Office Action Summary

10/600,479

ASANO ET AL.

Fig. 4a

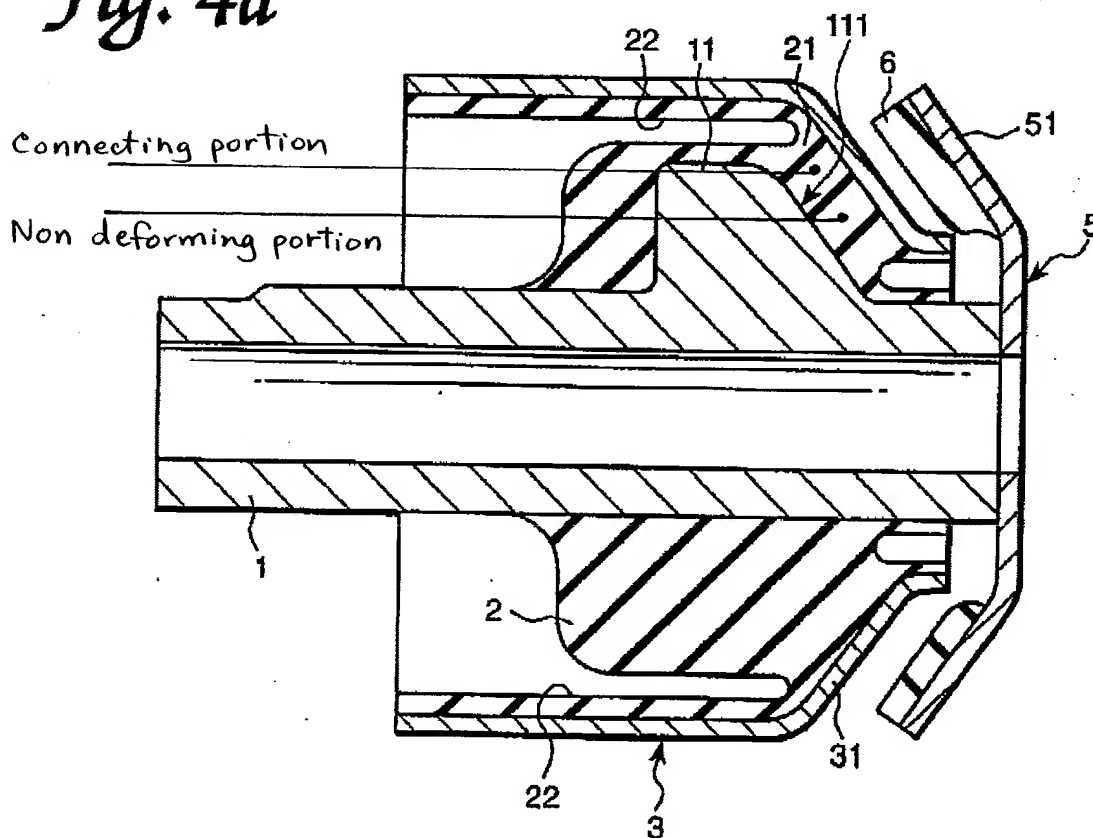
Re: claim 1, Hadano shows a vibration isolating bushing, as in the present invention, comprising: a main shaft member 1, 5 including a tubular portion 1, a flange portion 5 extending radially outwardly from one end of the tubular portion, and a block portion 11 provided on a central portion of the tubular portion and distanced from the flange portion an axial direction of the main shaft member; an outer cylinder member 3 disposed coaxially on an outer side of the main shaft member distance therefrom; and a rubber elastic body 2 disposed between the main shaft member and the outer cylinder member integral connection of the main shaft member and the outer cylinder member, rubber elastic body including a hollow portion 22 which is open in an end face away from the flange portion and extends in the axial direction up to the vicinity of an end face on a side the flange portion; wherein the rubber elastic body further includes non-deforming rubber portion, please see the figure below, and a connecting portion, see the figure below; the non-deforming rubber portion is positioned between the flange portion and the block portion and is substantially undeformable with respect to an

application of an axial load; the connecting portion is positioned between a bottom the hollow portion and the end face of the rubber elastic body on the side of the flange portion, for connecting the non-deforming rubber portion and an inner peripheral surface of an end portion of the outer cylinder member.

Re: claim 2, Hadano shows the block portion 11's radially outwardly protruding end face as claimed.

Re: claim 3, Hadano further shows the connecting portion to be offset inwardly compared to the non-deforming portion.
